A47 corridor improvement scheme
Public consultation report
A47 Great Yarmouth junctions

A47 Great Yarmouth Junction Improvements

Report on Public Consultation

August 2017

2.2 The Proposed Options

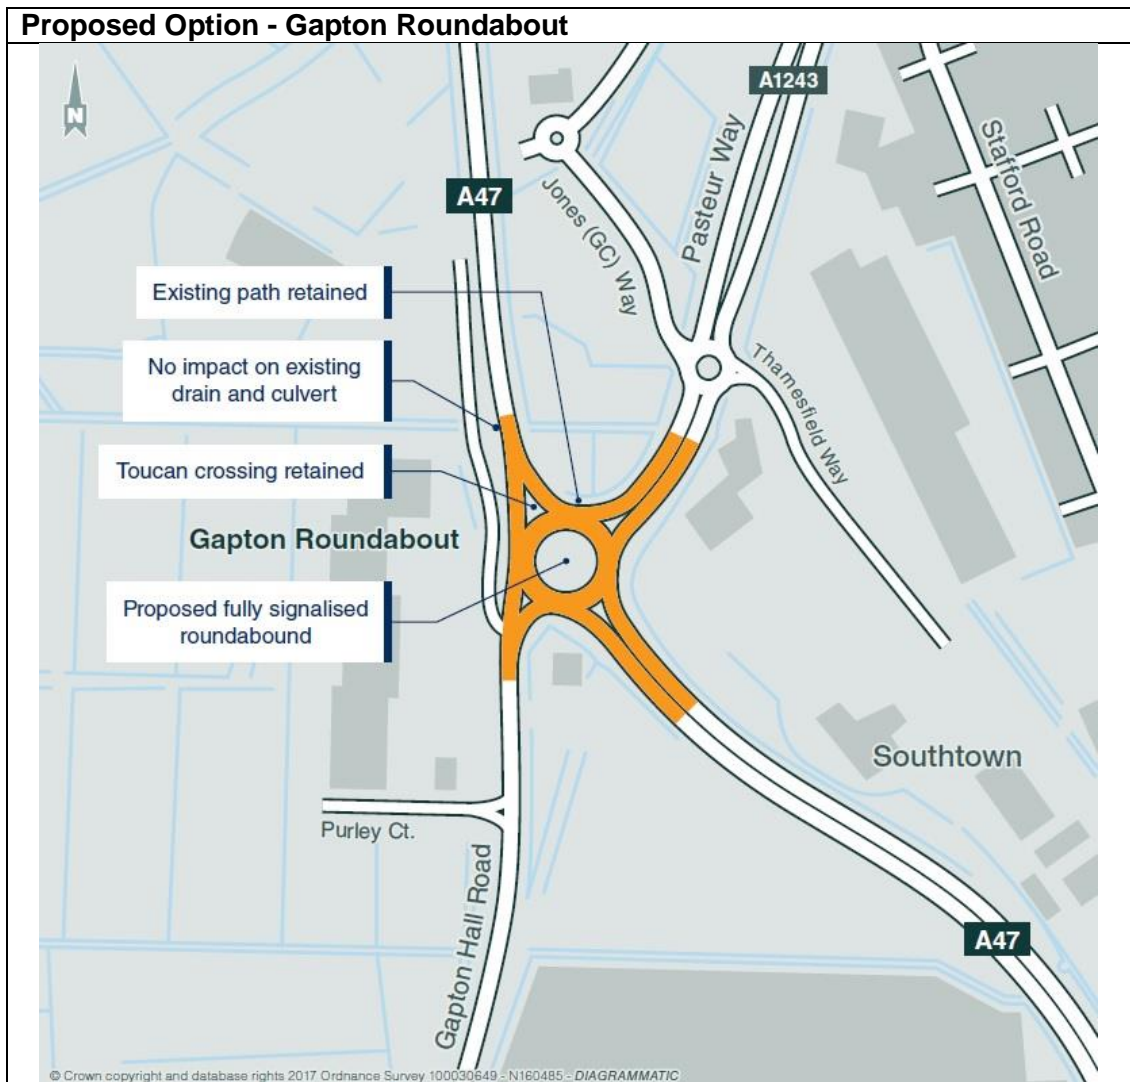
7.2.1 Several respondents comment that the changes proposed for Vauxhall Roundabout will successfully improve traffic flow by increasing the capacity of the roundabout. A few respondents also say that the added signals as well as the oval shape of the roundabout will address bad driver behaviour issues which contribute to congestion.

- 7.3.2 The Broads Authority raises several concerns about the proposals for Vauxhall Roundabout. They express concerns about the visual impacts of the proposal and say that the extension of the carriageways could have a negative impact on the Breydon Water area. They request further justification of why the land-take required for the proposed changes could not be restricted to the east of the A47, instead of the Breydon Water side. They also comment that the new bridging of the railway to the south of Vauxhall Roundabout could have a visual impact, although they concede that the impact could be negligible as this entails the widening of a bridge that already exists.
- 7.3.3 One respondent comments on the need for efficient surface water drainage. They state that previous road alterations have not taken this into account which has led to damage to their property.

- 7.4.1 Several respondents make suggestions for how the proposed changes at Vauxhall Roundabout could be improved. A few comment that lane separation is required to separate Great Yarmouth bound traffic and Acle bound traffic.
- 7.4.2 Some respondents comment that much of the traffic during the holiday season comes from drivers travelling to Caister and the northern part of Great Yarmouth which causes a tailback on the roundabout. They suggest a slip road is required to divert this traffic before it arrives at the roundabout.

“The proposed improvements at Vauxhall Junction should be designed so as to ensure that the revised junction is capable of incorporating future dualling of the Acle Straight; both in terms of its ability to accommodate traffic flows as well as in terms of its physical alignment .” - Norfolk County Council

9.2.1 The most common reason for support given by respondents (including Suffolk County Council) is that the new right turn option will benefit traffic flow on the Vauxhall Roundabout, allowing direct access from Great Yarmouth railway station and ASDA onto the A149 Acle New Road southbound towards Great Yarmouth town centre. One respondent believes that this will encourage people to shop in the centre of town rather than head straight home. Some respondents, including Norfolk County Council, call for this change to be made as soon as possible, ahead of the other junction improvements.

- 9.4.1 Some respondents provide additional suggestions to the proposed option for Station Approach. A few respondents suggest that Vauxhall Bridge over the river Bure could be repaired and used for light traffic. This would allow direct access to the town centre, North Quay and Staples roundabout without requiring a right turn from Station Approach.

11.2.1 Few respondents express support for the changes proposed for Gapton Roundabout in their comment. Of those who do, some suggest that traffic signals will benefit the traffic flow and reduce the number of accidents. One respondent comments that the changes proposed will only ease congestion if the lights favour traffic bound for Great Yarmouth.

- 11.3.1 Several respondents who comment on the changes to Gapton Roundabout express concern that the traffic lights will not address current issues and will create further congestion and request that all traffic lights should be removed from this roundabout. Respondents, including Suffolk County Council, refer to a previous signalling scheme implemented at this junction which was unsuccessful in improving traffic flow and was subsequently removed. They comment that the removal of these traffic lights improved traffic flow and one comments that traffic flowed freely when the traffic lights were not working.
- 11.3.2 One respondent queries how the proposed changes to Gapton Roundabout will address the issue of drivers going around the roundabout instead of turning from the appropriate lane (as mentioned above in Section 6).

- 11.3.3 A few respondents comment that the proposals must include improved access in and out of Purley Court for Gapton Hall Retail Park. They believe that this is required to successfully address traffic flow issues on Gapton Hall Road. Norfolk County Council asks for further information on how the proposed changes to Gapton Roundabout will impact the entrance to Gapton Hall Retail Park. A few respondents comment that Gapton Roundabout has a confusing layout with roads merging quickly and poor road markings leading to hazardous driver behaviour.
- 11.3.4 Several respondents express opposition to the proposal to retain the toucan crossing where it is, as they say it causes traffic issues on the roundabout and for drivers travelling north towards Vauxhall Roundabout. Some suggest removing it or moving it further away from the roundabout.

- 11.4.1 Some respondents suggest that clearer markings are required to guide drivers into the correct lane.
- 11.4.2 Other suggestions for improvements to Gapton Roundabout include:
- A slip road for those travelling north onto Gapton Hall Road onto the A47, which would reduce traffic on the roundabout;
 - ‘Ovalising’ the roundabout and extending the length of dualling proposed for the junction access points, allowing more time for traffic to merge;
 - Reducing the size of Gapton Roundabout and installing traffic lights installed on the roads leading to it;
 - A flyover over the roundabout;
 - A left turn onto the A47 from Tesco.

- 16.2.4 The proposed improvements at Vauxhall Junction should be designed to ensure that the revised junction is capable of incorporating future dualling of the Acle Straight; both in terms of its ability to accommodate traffic flows as well as in terms of its physical alignment.
